**FINAL DRAINAGE REPORT FOR
HCD DRILLING
2601 EAST PLATTE AVENUE
COLORADO SPRINGS, COLORADO 80916**

July, 2021
Revised April, 2022

Job No. 1895.00
PCD Filing No.: MS-21-008

FULL SPECTRUM EXTENDED DETENTION BASIN DETAIL

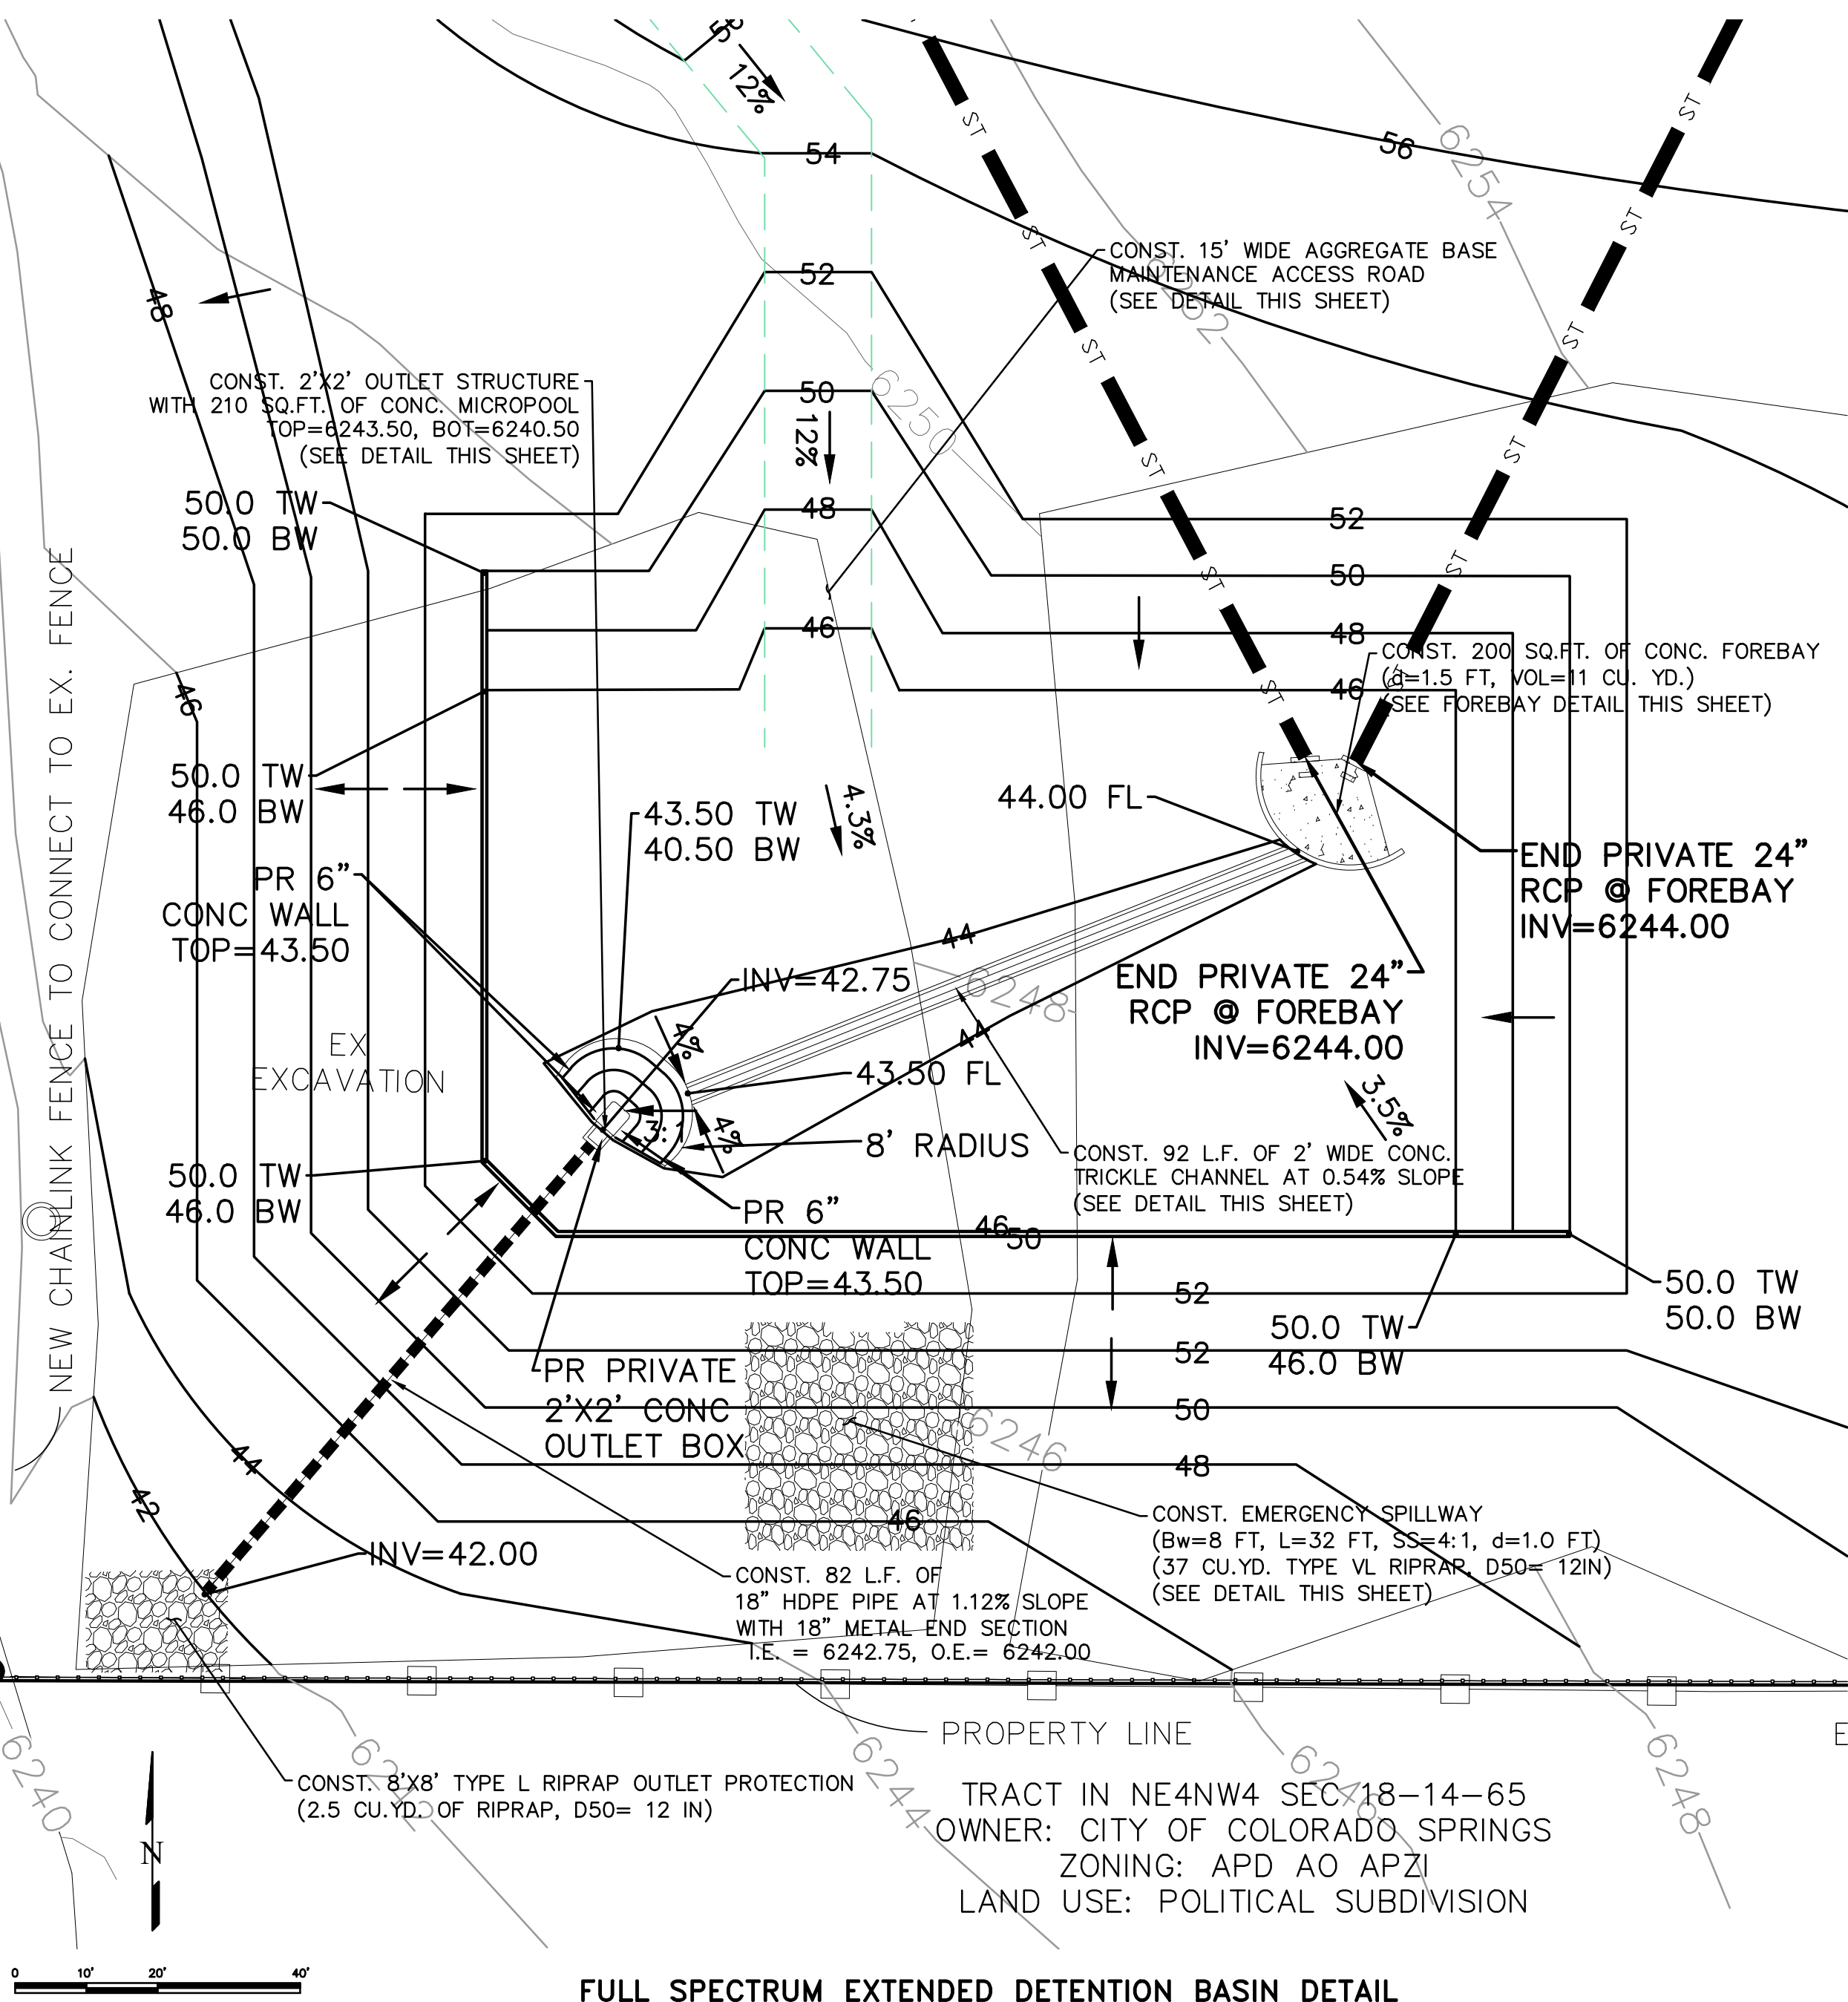
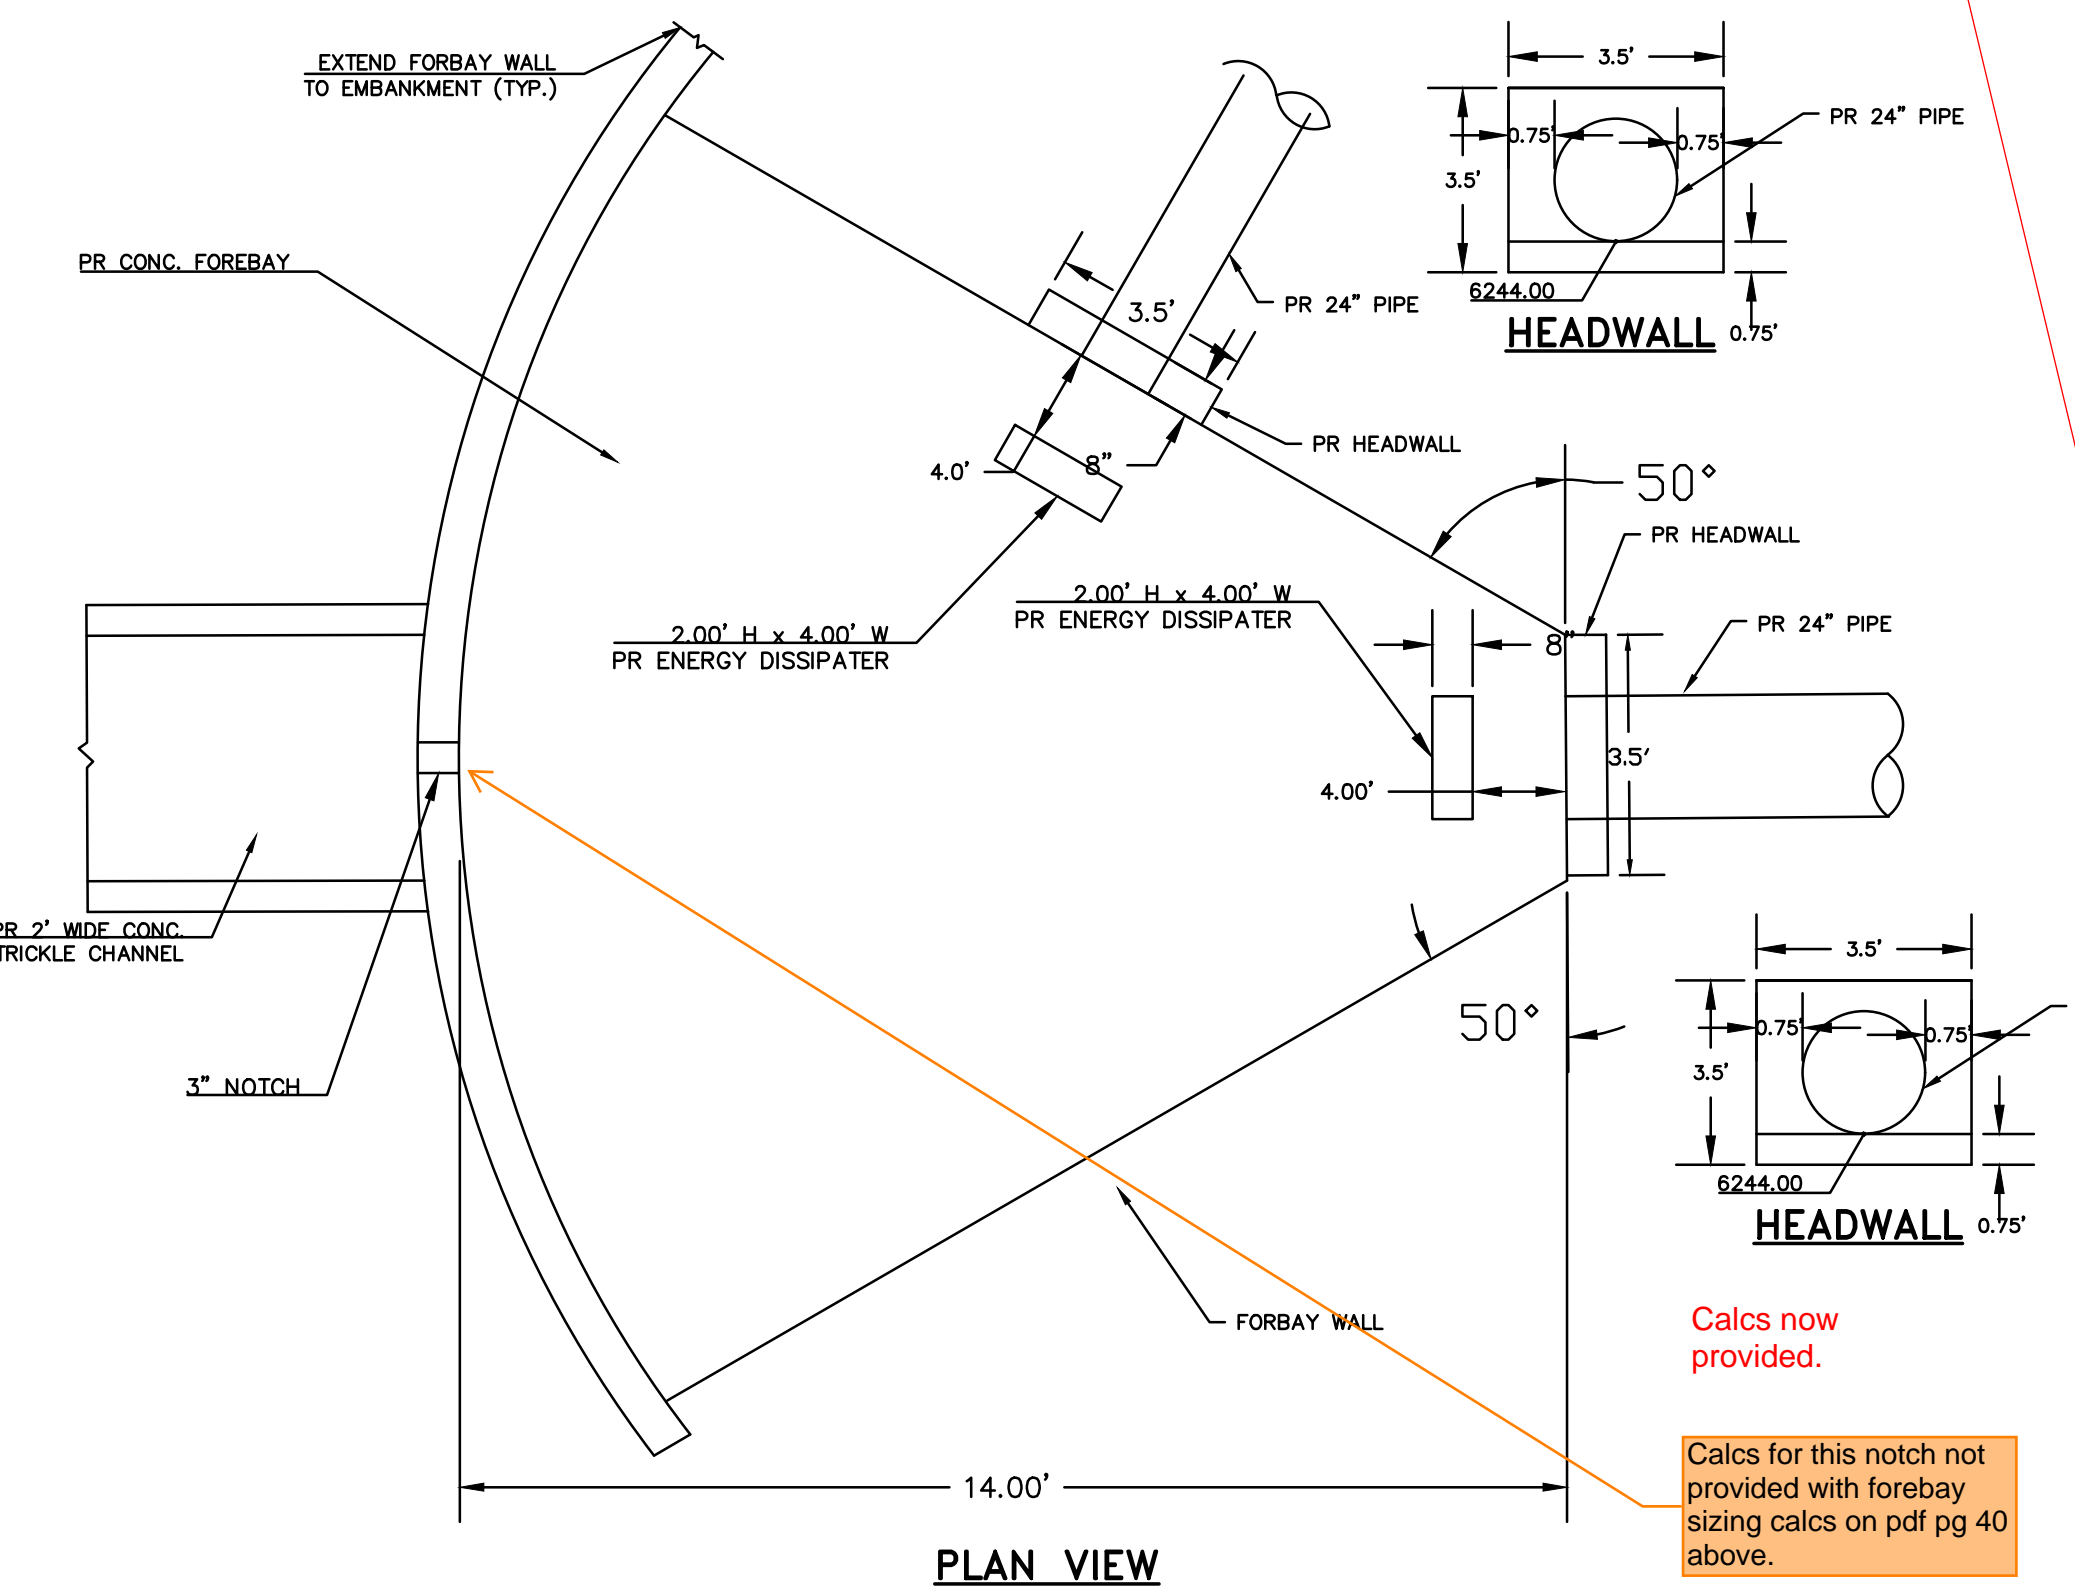
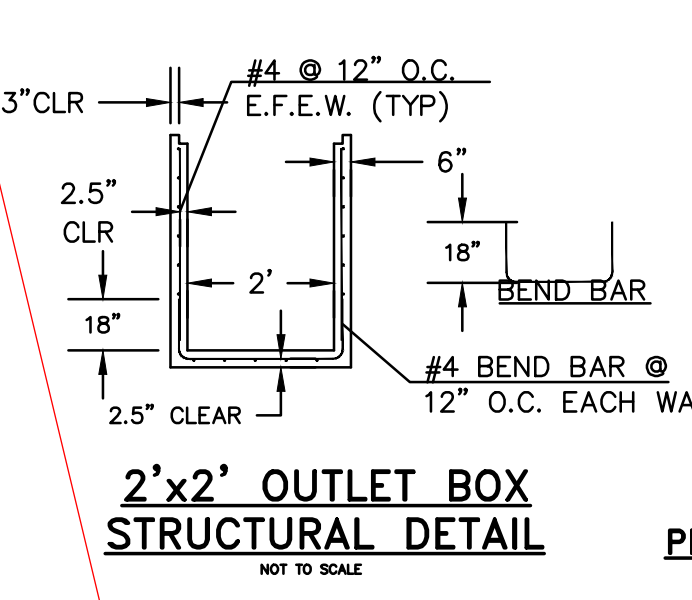
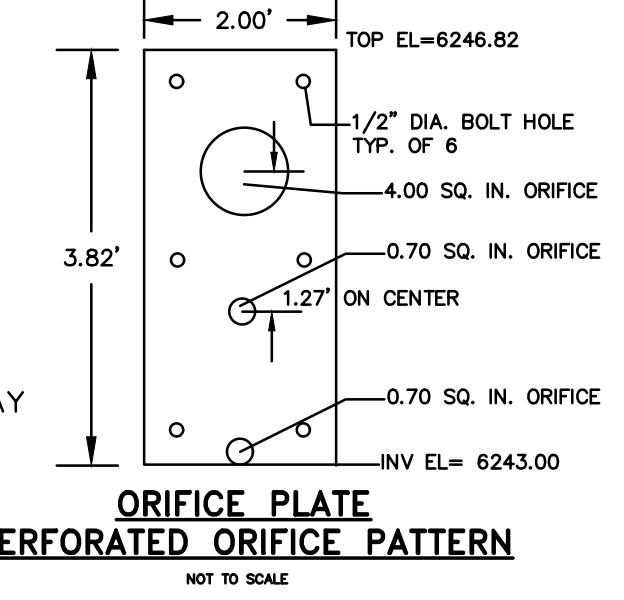
Figure OS-4 not provided on Sheet 4. So no trash rack details were provided.
Revised with correct information.

Unresolved Review #1 comment: Include forebay and micropool sizing and well screen calcs with this drainage report. MHFD has the UD-BMP spreadsheet that does these calcs for you.
Review #2 update: Forebay and micropool sizing calcs are provided on pdf pg 40 above. But still missing calcs for forebay notch and well screen. The UD-BMP spreadsheet will do those calcs quickly. You can upload a printout of it to this drainage report.

Trash rack details have been revised. And other details provided below.
